**Medway Planning & Economic Development Board
Meeting**

**Master's Touch Minor Site Plan Public
Briefing – 83 Main Street**

**Re: Master's Touch
Minor Site Plan Review
83 Main Street
Medway, Massachusetts**

EXISTING CONDITIONS

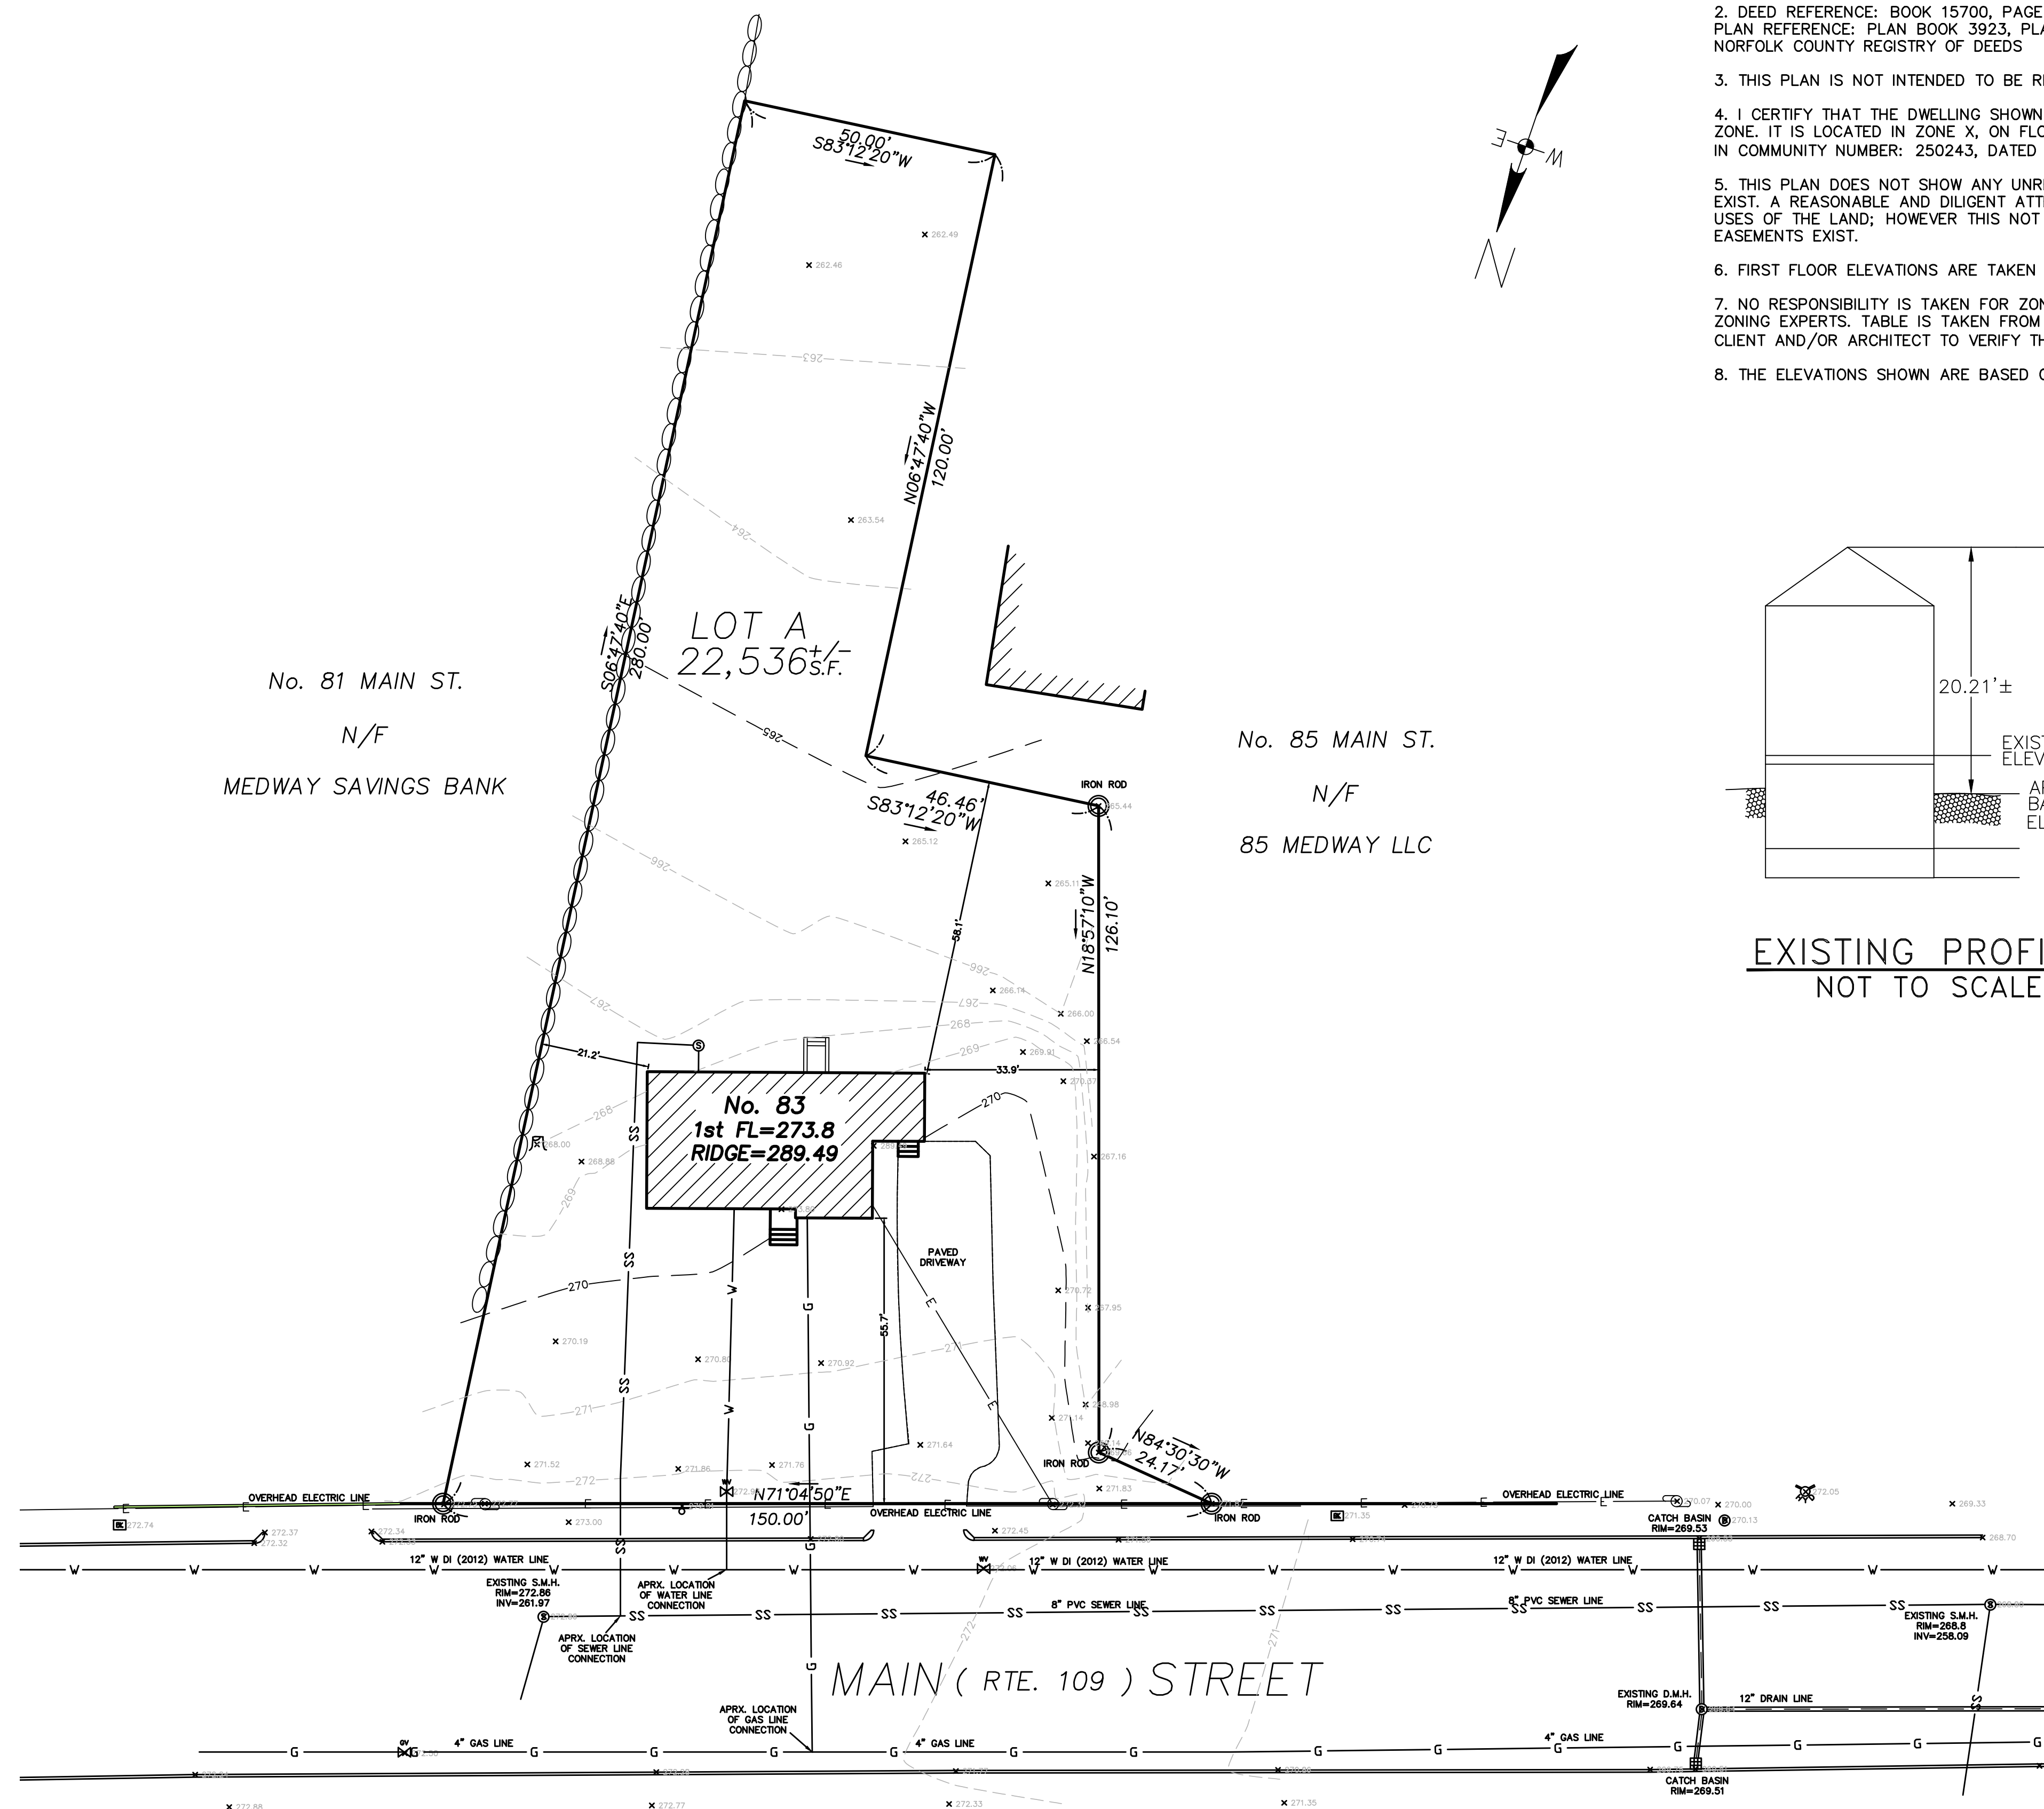
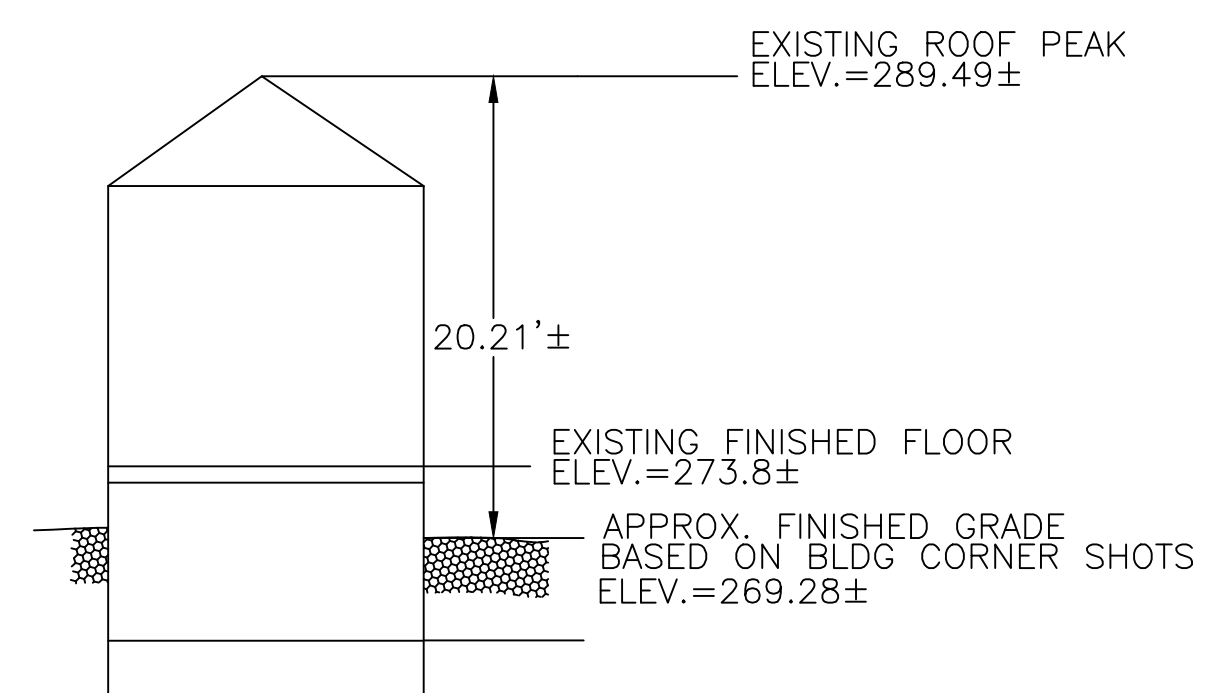
23. It is unclear whether the Applicant intends to install new water service connections for the Project. The Civil Plan notes that both connections are existing but only one connection is shown on the Existing Conditions Plan. The Applicant shall confirm the proposed water service connections and coordinate all work with the Medway DPW. (Ch. 200 §207-15.A)
